# UNITED STATES PATENT AND TRADEMARK OFFICE

APPLICATION NO.	FILING DATE	FIRST NAMED INVENTOR	ATTORNEY DOCKET NO.	CONFIRMATION NO.
10/565,999	10/06/2006	Kiyohiro Shimokawa	285290US3XPCT	9543
22850	7590	02/28/2008		
OBLON, SPIVAK, MCCLELLAND MAIER & NEUSTADT, P.C. 1940 DUKE STREET ALEXANDRIA, VA 22314			EXAMINER TRIEU, THAI BA	
			ART UNIT 3748	PAPER NUMBER
			NOTIFICATION DATE 02/28/2008	DELIVERY MODE ELECTRONIC

<b>Office Action Summary</b>	<b>Application No.</b>		<b>Applicant(s)</b>	
	10/565,999		SHIMOKAWA ET AL.	
	<b>Examiner</b>		<b>Art Unit</b>	
	Thai-Ba Trieu		3748

## DETAILED ACTION

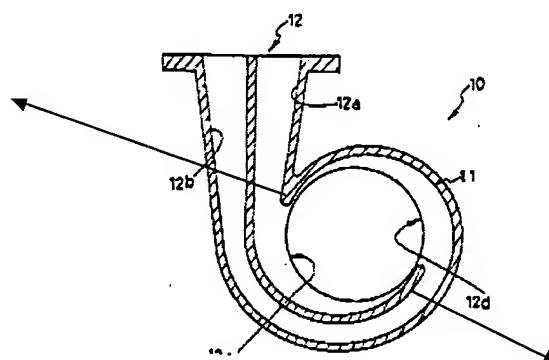
The modified Heydrich/Pierport discloses the invention as recited above; however fails to disclose tongues and their positions

Takeda Toshio/Birmann teaches that it is conventional in the turbocharger art, to utilize tongues (Not Numbered) being respectively provided at two circumferential

positions of the turbine scroll, an exhaust inflow range from the tongue near the exhaust inflow port to the tongue away from the exhaust inflow port providing a throat portion only for one of the flow paths, the remaining exhaust inflow range from the tongue away from the exhaust inflow port back to the tongue near the exhaust inflow port providing a throat portion only for the other flow path (See Figure 1 of Takeda Toshio, Figure 2 of Birmann).

It would have been obvious to one having ordinary skill in the art at that time the invention was made, to have utilized tongues and their positions, as taught by Takeda Toshio/Birmann, to improve the efficiency of the modified Heydrich/Pierport device, since the use thereof would have delivered the desired exhaust gas flow to each throat portion of the turbine with respect to the condition of engine speed/operation.

the tongue near the  
exhaust inflow port

the tongue away from the  
exhaust inflow port
